CITY OF CONWAY, ARKANSAS PLANNING COMMISSION

September 21, 2020 · 7:00pm · City Hall · 1111 Main Street

Request for Preliminary Plat Approval - Ivy Place Subdivision

Request for Preliminary Plat Approval - Orchard Hill Subdivision, Phase II

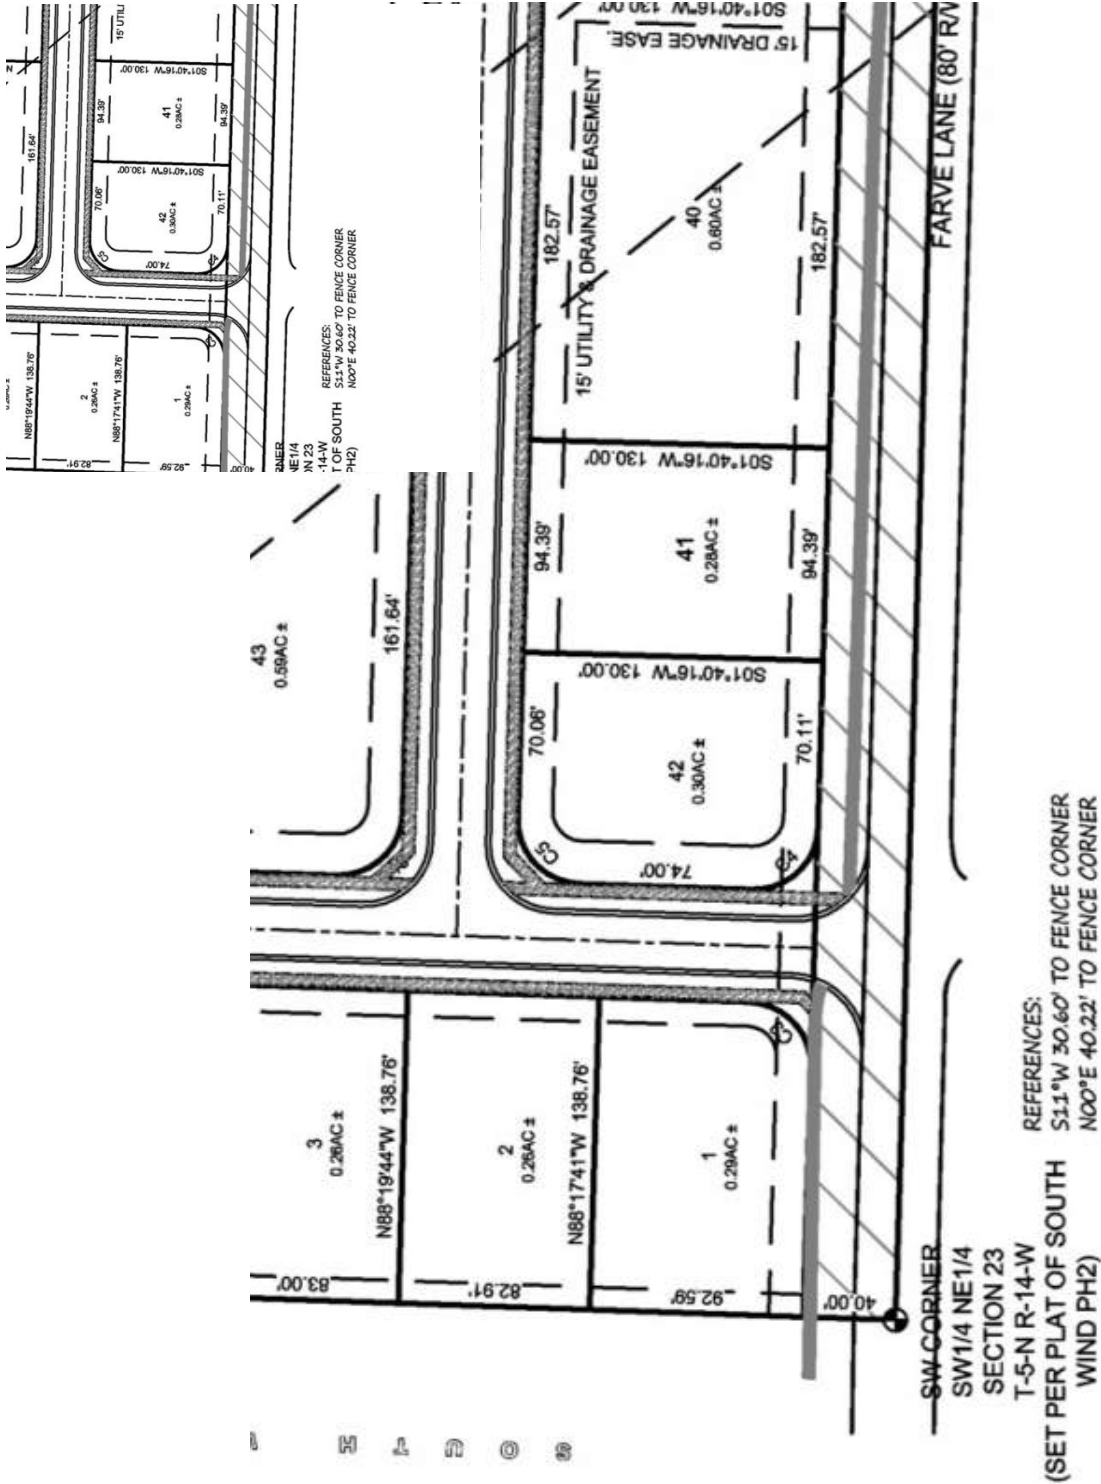
1. Show all hydrant locations.
2. Corrections as noted on Preliminary Plat.

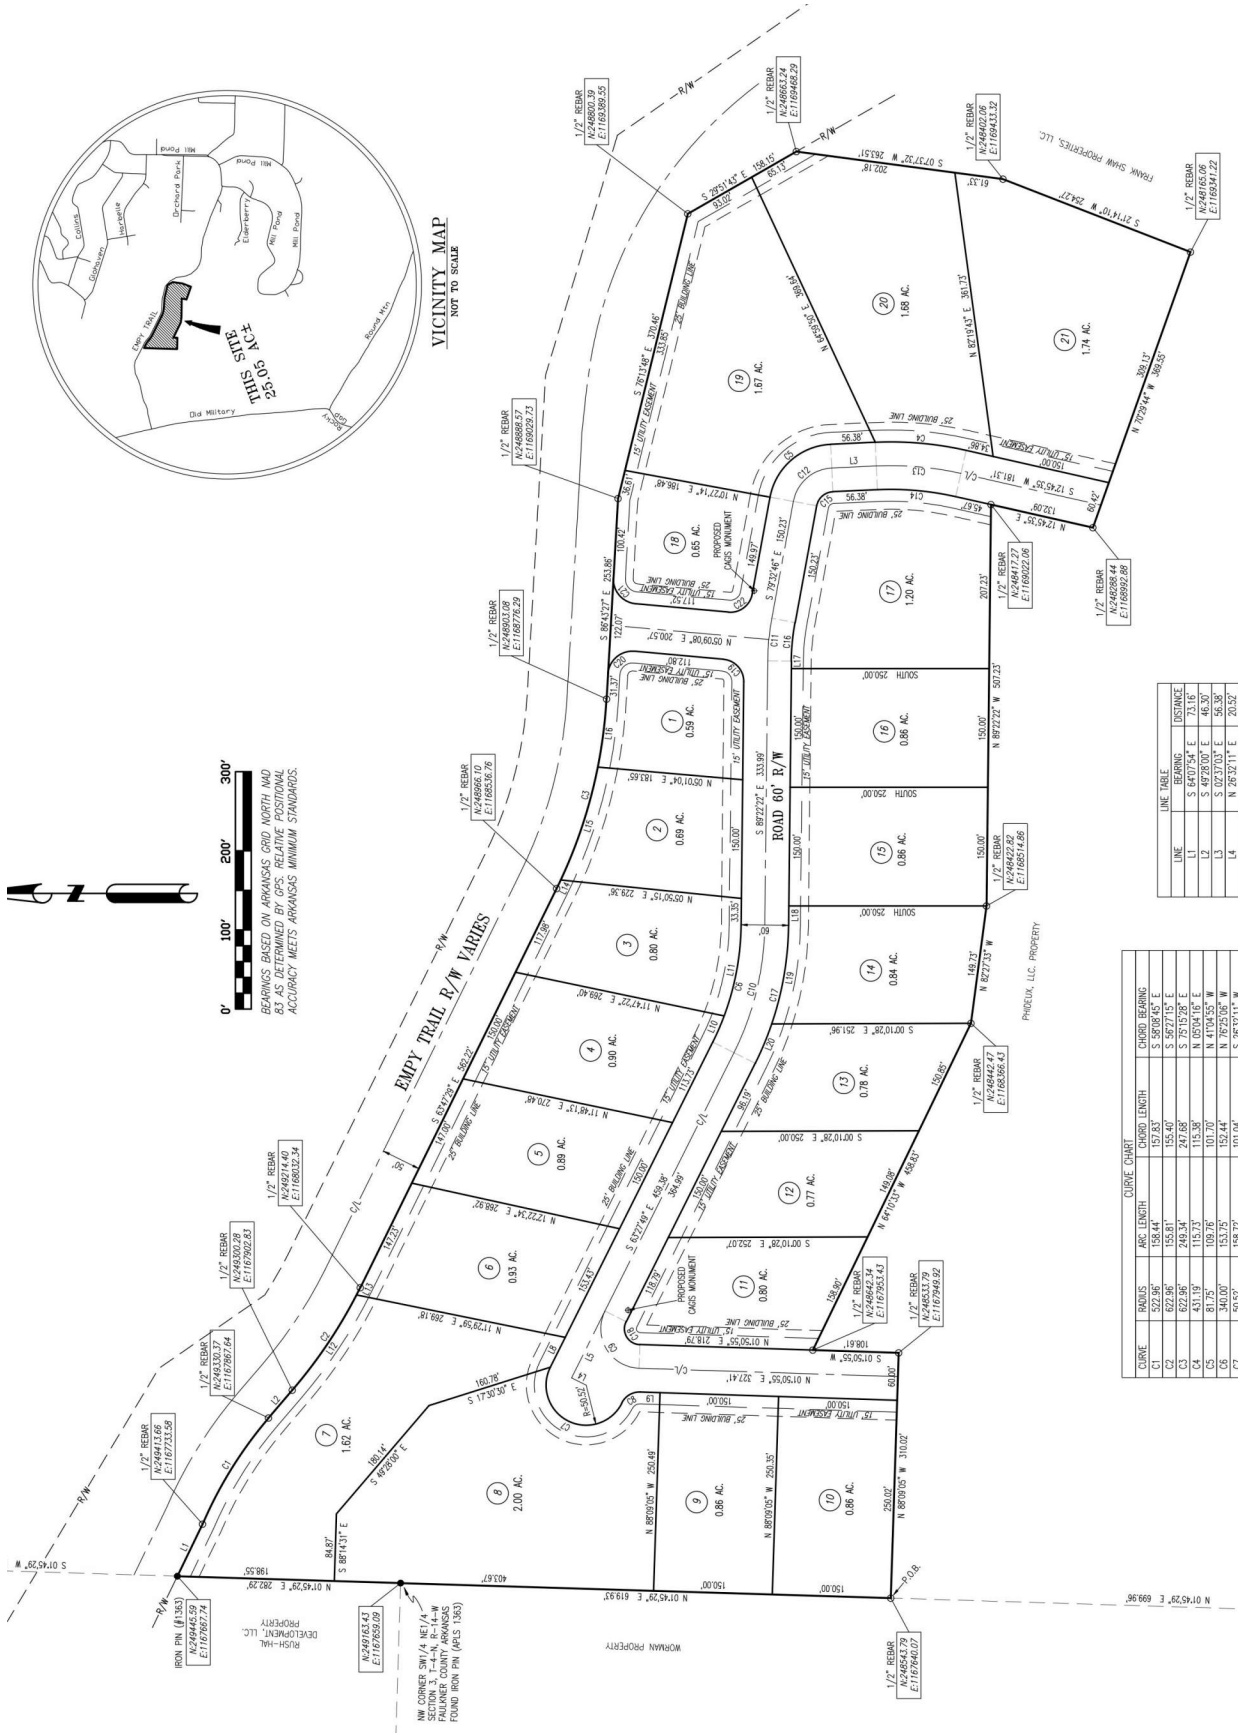
1. Show all hydrant locations.
2. Corrections as noted on Preliminary Plat.
3. Department of Health shall approve all Septic Systems prior to filing final plat.

3. State Fire Code 503.0.5 states that dead-end fire apparatus access roads in excess of 150 feet in length shall be provided with an approved area for turning around fire apparatus. Anything other than the following cul-de-sac requirement must be approved by the Conway Fire Marshall. *Preliminary Plat Approval conditioned upon Fire Department approval of access and turn around requirements for new street termination.*
